SUBJECT: VOGTLE ELECTRIC GENERATING PLANT, UNITS 1 AND 2 – FLOOD
HAZARD MITIGATION STRATEGIES ASSESSMENT (CAC NOS. MF7987 AND
MF7988)

STAFF ASSESSMENT BY THE OFFICE OF NUCLEAR REACTOR REGULATION
RELATED TO MITIGATION STRATEGIES FOR
VOGTLE ELECTRIC GENERATING PLANT, UNITS 1 AND 2
AS A RESULT OF THE REEVALUATED FLOODING HAZARD
NEAR-TERM TASK FORCE RECOMMENDATION 2.1- FLOODING

Figure 3.2.0-1. Site topographic map with FLO-2D model boundary and security barriers (taken from SNC (calc. package - VMSA-0040_1-X2CA91_Ver1_0-VogtleLIPCalc).

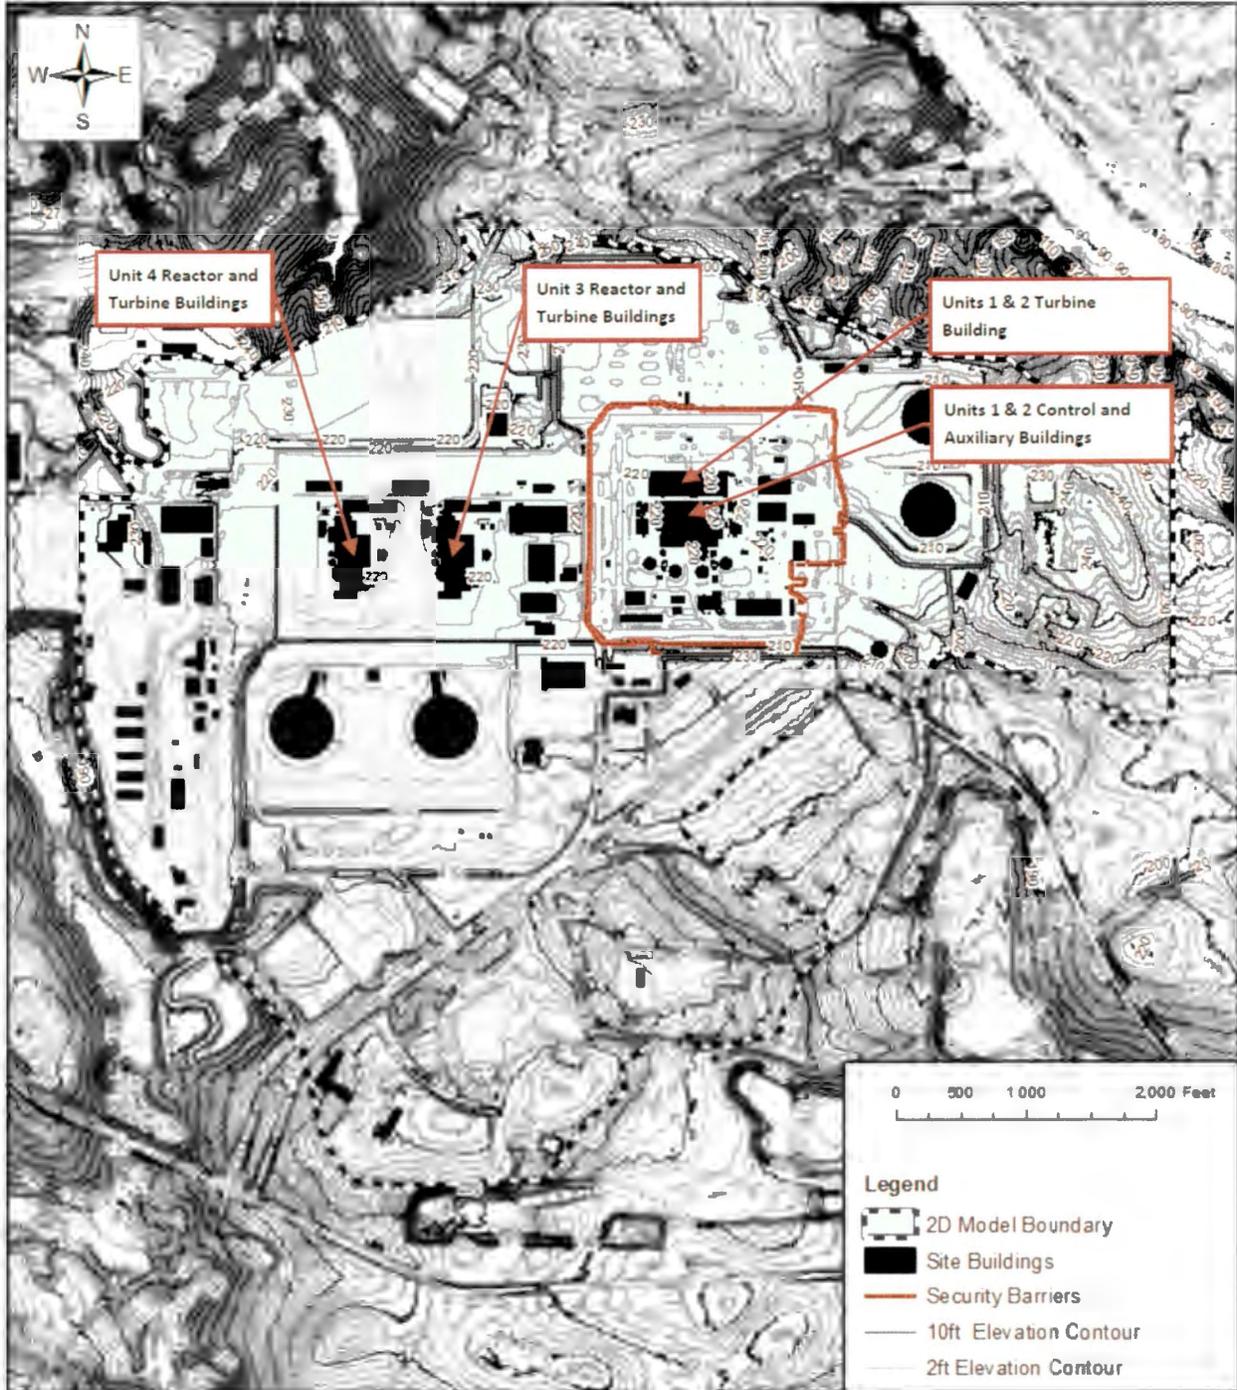
The licensee used the FLO-2D Pro Build No. 16.02.14 to simulate LIP-induced flood elevations. The computational domain of the LIP model encompasses the entire Vogtle site, including the Units 1 and 2 area, the Units 3 and 4 area, and the watershed basin contributing to the area surrounding to the plant (see Figure 3.2.0-1 of this assessment). A uniform 10-ft. square grid scheme was applied over the model domain, having a total of 380,895 grid cells. The licensee mentioned this grid resolution allowed for representing each building by at least one grid cell and enabled the representation of roads and channels adequately. The NRC staff confirmed based on a review of the Google maps that the licensee's model boundaries are adequate to capture the effects of runoff from the plant buildings and surrounding areas.

- The FLO-2D model was constructed using the current security barrier alignment surrounding Units 1 and 2 and the future site grading information for Units 3 and 4 as shown on Figure 3.2.0-1 of this assessment.

Figure 3.2.0-2. Map showing the maximum inundation depths for the LIP flood-causing mechanism using the FLO-2D model (taken from calc. package - VMSA-0040_1-X2CA91_Ver1_0-VogtleLIPCalc).

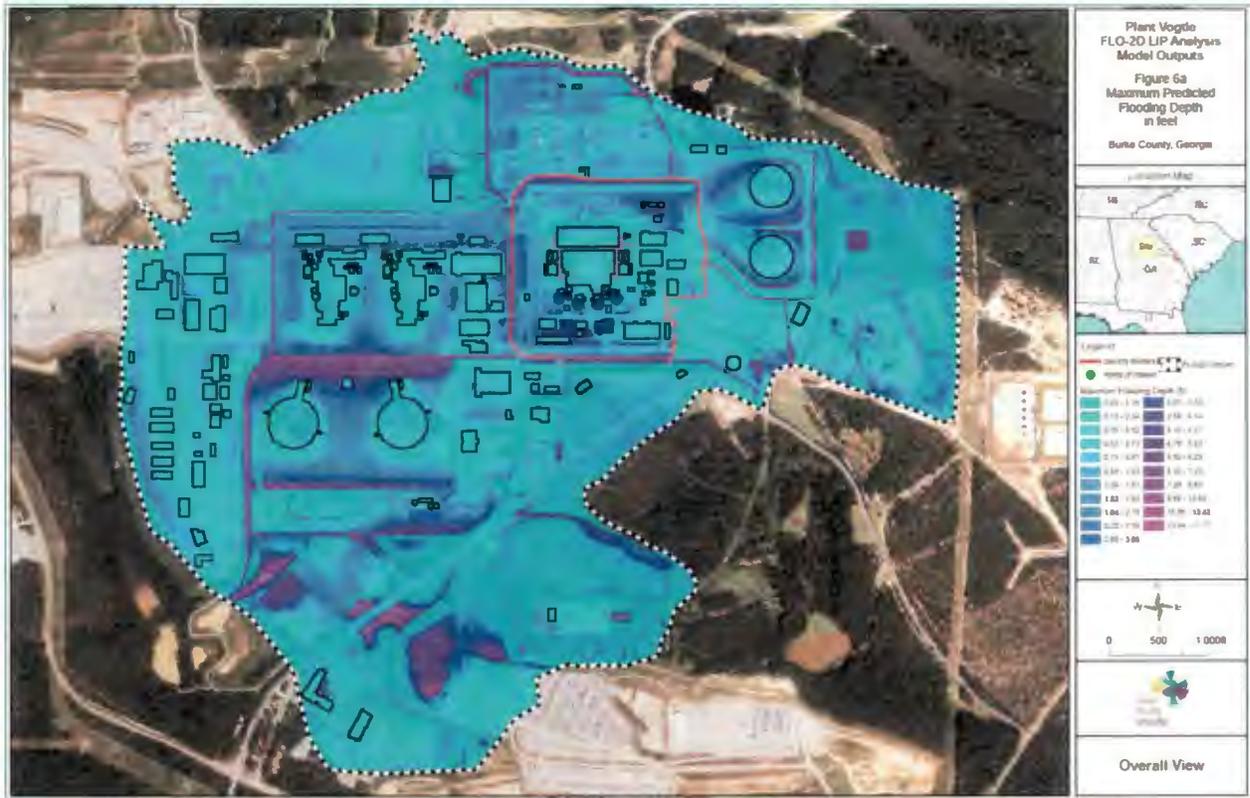
The licensee provided the maximum water surface elevations at selected monitoring locations near safety-related building doors (MSA Table 5-1) and at major haul pathways (MSA Table 5-2). Figure 3.2.0-2 of this assessment displays the spatial distribution of the maximum LIP flood inundation depths within the model area. The licensee reported a maximum LIP flood elevation within the power block area of approximately 220.5 ft. MSL. This maximum flood level would occur at the CST Valve Gallery Doors for both Units 1 and 2 (see Figures 3.2.0-3 and 3.2.0-4 of this assessment).

The NRC staff reviewed the licensee-provided LIP FLO-2D model output files and confirmed the maximum flood elevations reported in the MSA. The staff performed a confirmatory run of the licensee-provided FLO-2D model and found no significant numerical instability in its solution or any water budget errors. Therefore, the staff conclude that the licensee's updated LIP flood modeling is acceptable for use in the MSA.
